# UNITED STATES PATENT AND TRADEMARK OFFICE

APPLICATION NO.	FILING DATE	FIRST NAMED INVENTOR	ATTORNEY DOCKET NO.	CONFIRMATION NO.
09/476,521	01/03/2000	Herbert Gropp	RUM212	7964

# Office Action Summary

Fig. 1

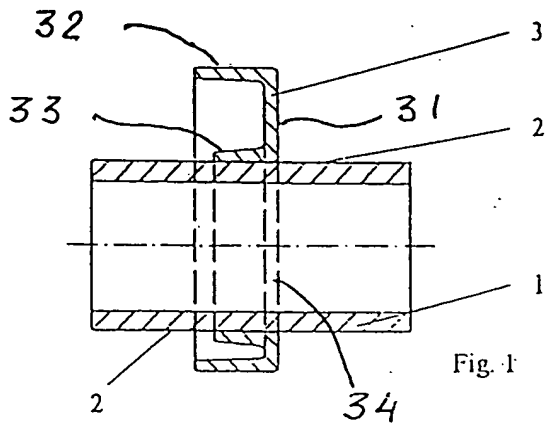
(C) The corrected Fig. 1 has been approved.

(a) the drawings should show the plane upon which a sectional view such as Fig. 1 is taken; and

Fig. 2

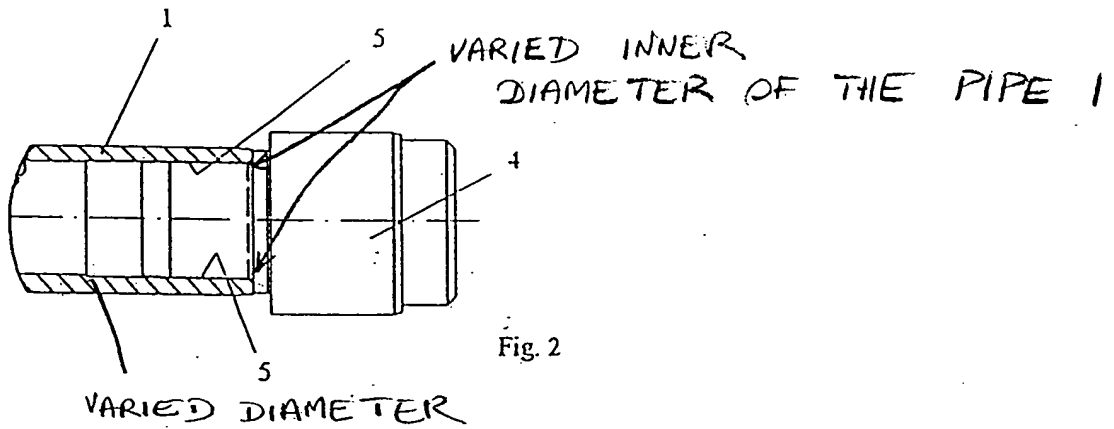
(a) new Fig. 4 introduces new matter such as the end piece 4 as now shown. The original Fig. 2 shows that the inner diameter of the pipe 1 is varied: (1) at the junction of the end piece 4 and the pipe 1 as shown by applicant's phantom line; and (2) at referential numeral 1 (see attached Exhibit). However, Fig. 4 shows that the inner diameter of the pipe 1 is constant. The

Not  
Approved  
VL  
10/20/00

Fig. 3

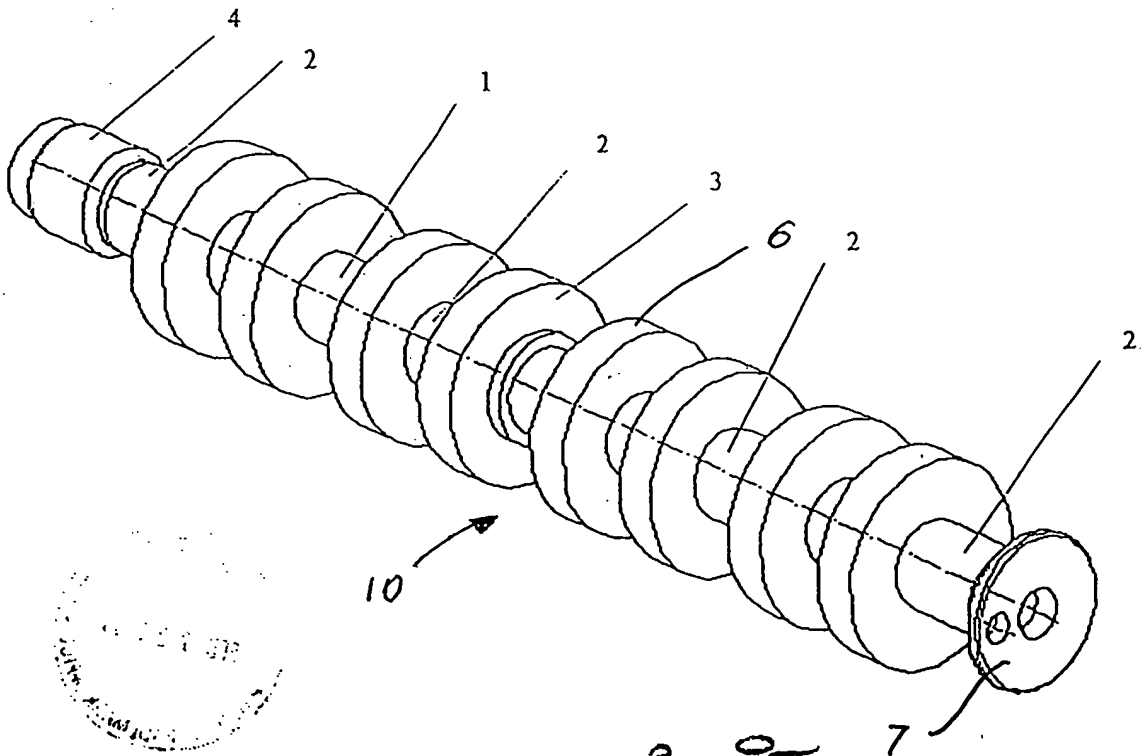
(B) The corrected Fig. 3 has been disapproved since it introduces new matter. The original drawings do not show the bearing rings. The corrected Fig. 3 now shows the bearing 6 which is identical to the cam 3. The showing and description of a specific type of bearing within a full spectrum of possible bearings is considered under the present disclosure to be new matter. *Cf., In re Smith*, 173 USPQ 679 (CCPA 1972) and *Ex parte George*, 230 USPQ 575, 578 (BPAI 1986).

(b) the orientation of the cams 3 as now shown in Figs. 11 and 18 is unsupported by the record as filed. In fact, the original Fig. 3 shows that the cams 3 are oriented in the same direction. However, new Figs. 11 and 18 show that the cams 3 are oriented in different directions (some are pointed to the left and some are pointed to the right). The different orientations of the cams 3 introduce new matter; and

EXHIBIT  
(PAGE 2 OF 2)

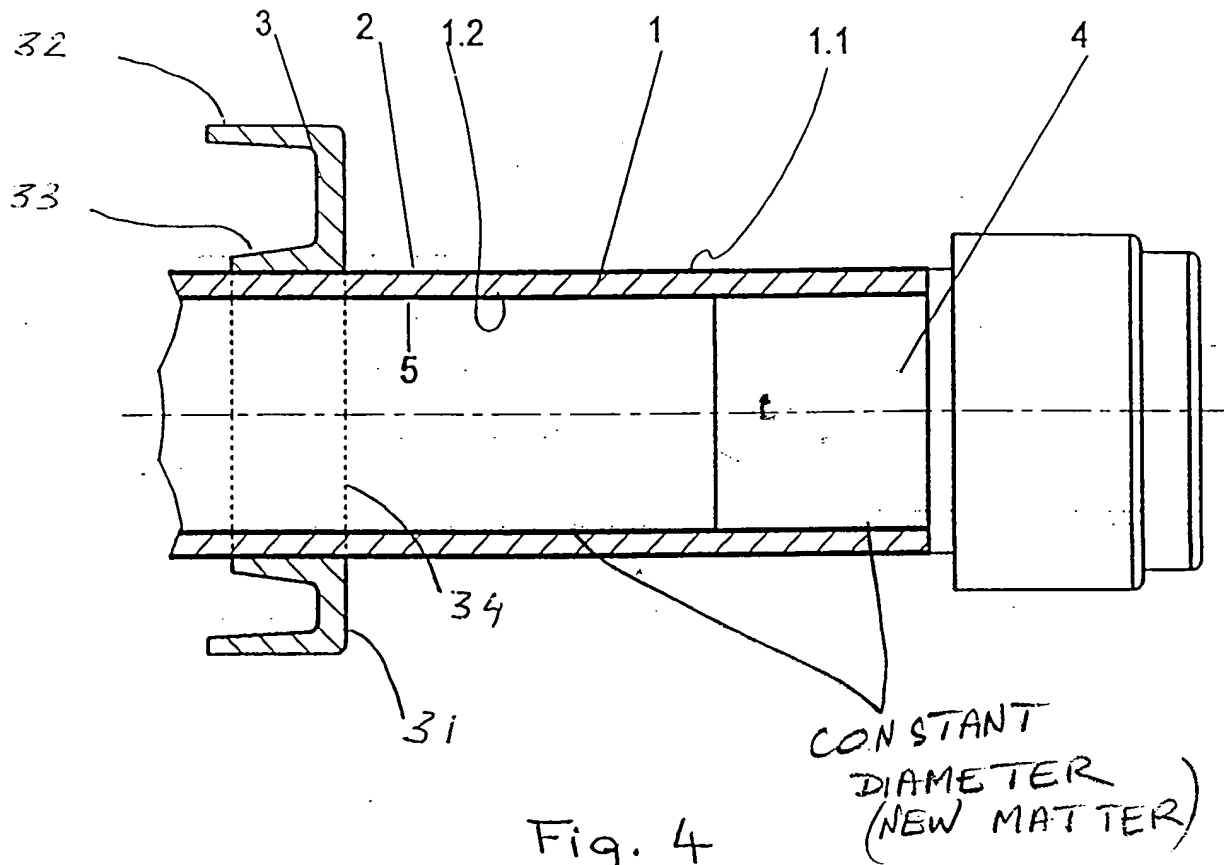
(A) New Fig. 4 has been disapproved because:

(b) new Fig. 4 is inconsistent with the description in Paper No. 9. The insertion on page 6, line 12 of the specification, states that the outer diameter of the end piece 4 is slightly larger than an inner diameter of the pipe 1. However, Fig. 4 shows that the outer diameter of the end piece 4 is equal to the inner diameter of the pipe 1.

Disapproved  
VL  
10/20/00
